**RFI 094
Pebble Project EIS**

Title/Subject:	Alternative Option to Develop Pebble East Using Underground Mining
Requestor:	AECOM
Date Transmitted:	10/10/2018
Recipient:	Pebble Limited Partnership (PLP)

From: James Fuego, Pebble Limited Partnership

Date: October 18th, 2018

FIGURE 1

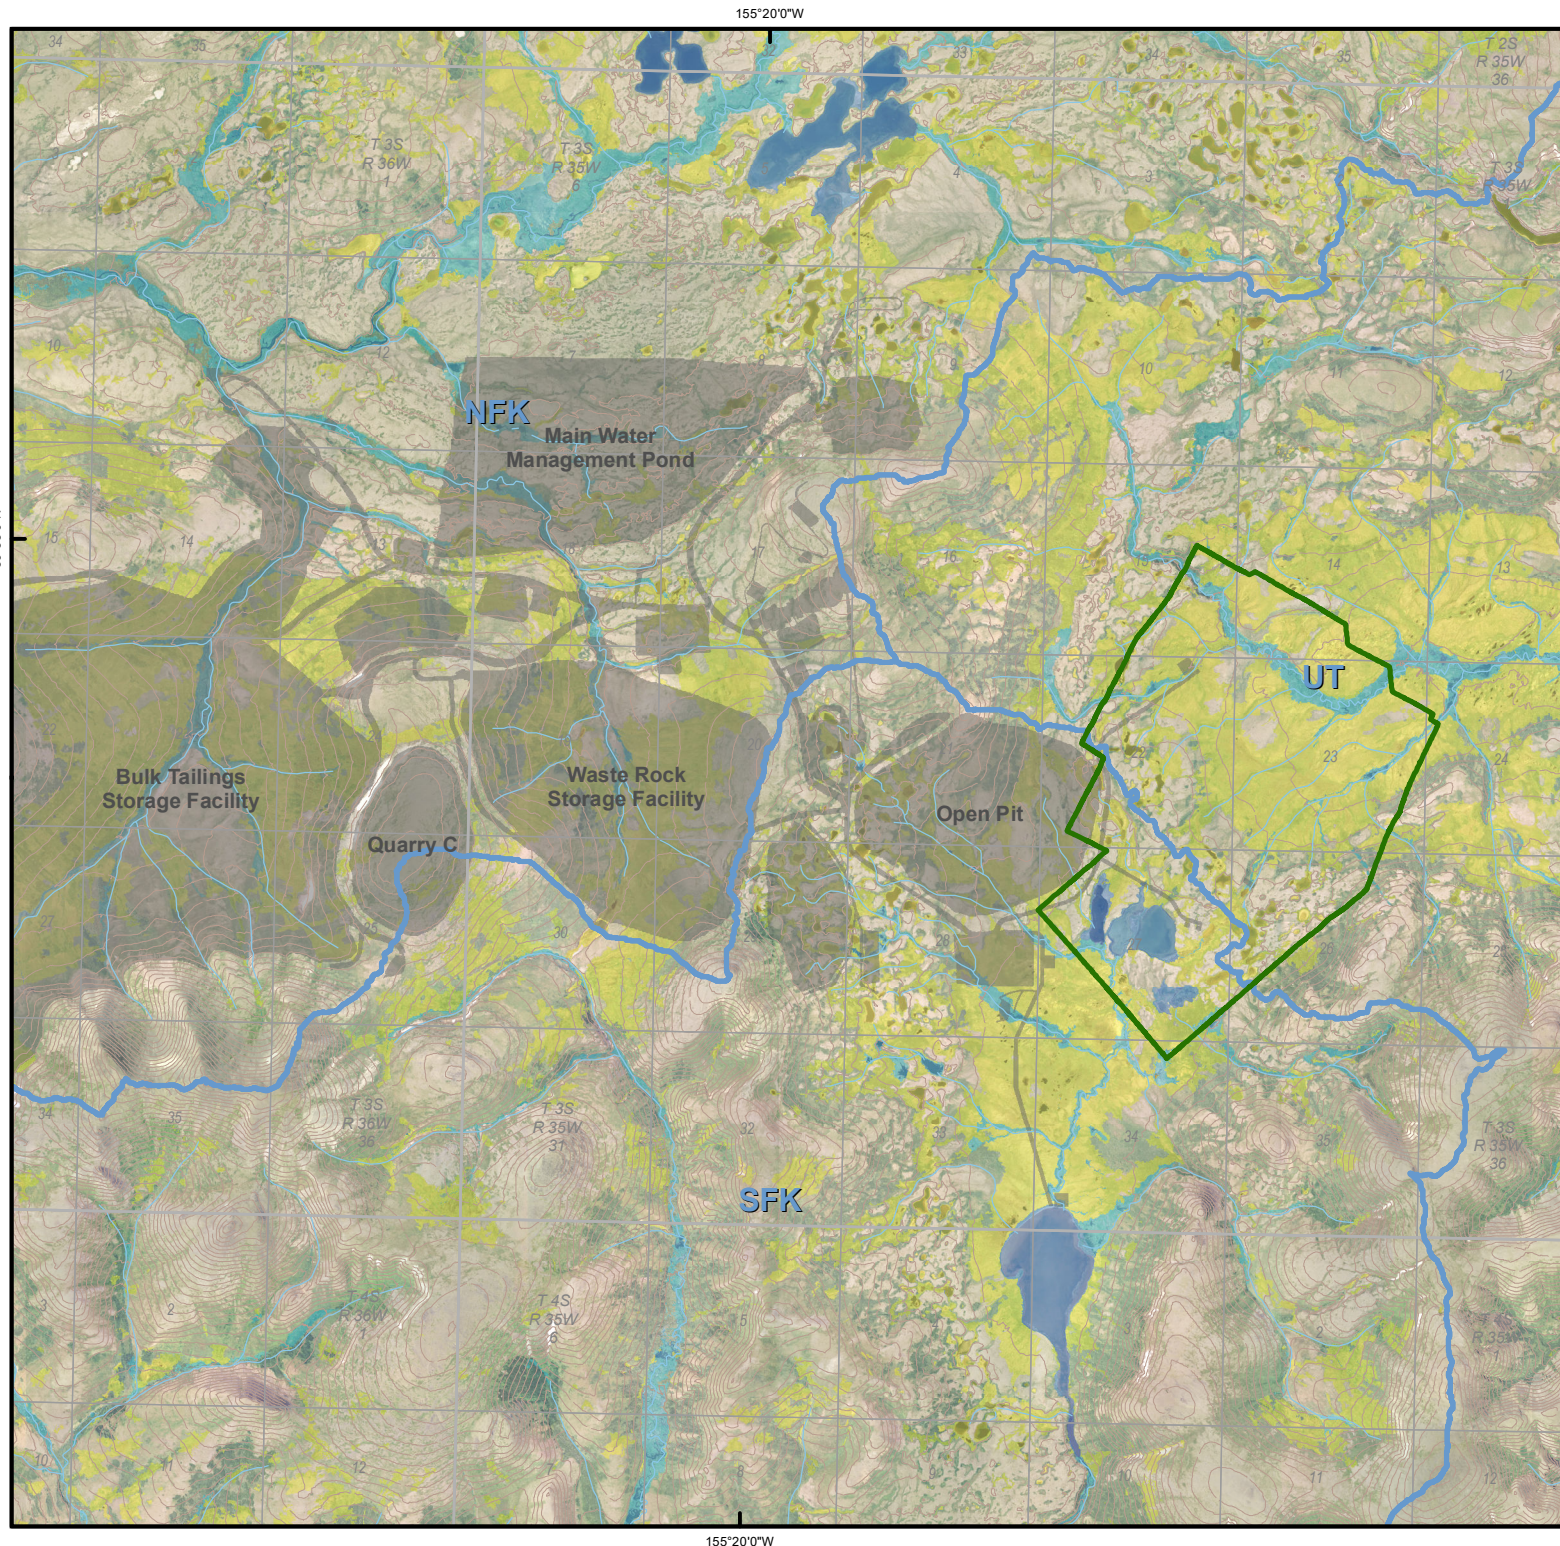
Please address the option of mining Pebble East instead of Pebble West, including using underground mining methods.

Please address the feasibility of underground mining and underground mining combined with surface mining. The following topics should be addressed, at a minimum:

- *Technical feasibility (including can underground mining be conducted without first mining Pebble West, can mining be conducted using solely underground methods, would surface mining combined with underground mining still be required, can the underground mine roof be stable with respect to subsidence?),*
- *Economic feasibility (including is the mineralized distribution within the ore deposit conducive to underground mining?),*

The block cave would result in a significant subsidence zone (Figure 1). Previous work utilized a cone defined by 55° from the horizontal, which is considered a reasonable assumption for this level of analysis. Portions of the subsidence zone could open into holes that are 1000 foot or deeper. The subsidence zone would have an area of approximately 2000 acres, of which approximately 1,300 acres are classified as wetlands and would extend well into the UTC watershed. The equivalent footprint for the proposed project pit is 608 acres, of which 207 are wetlands, with no direct impacts in the UTC watershed.
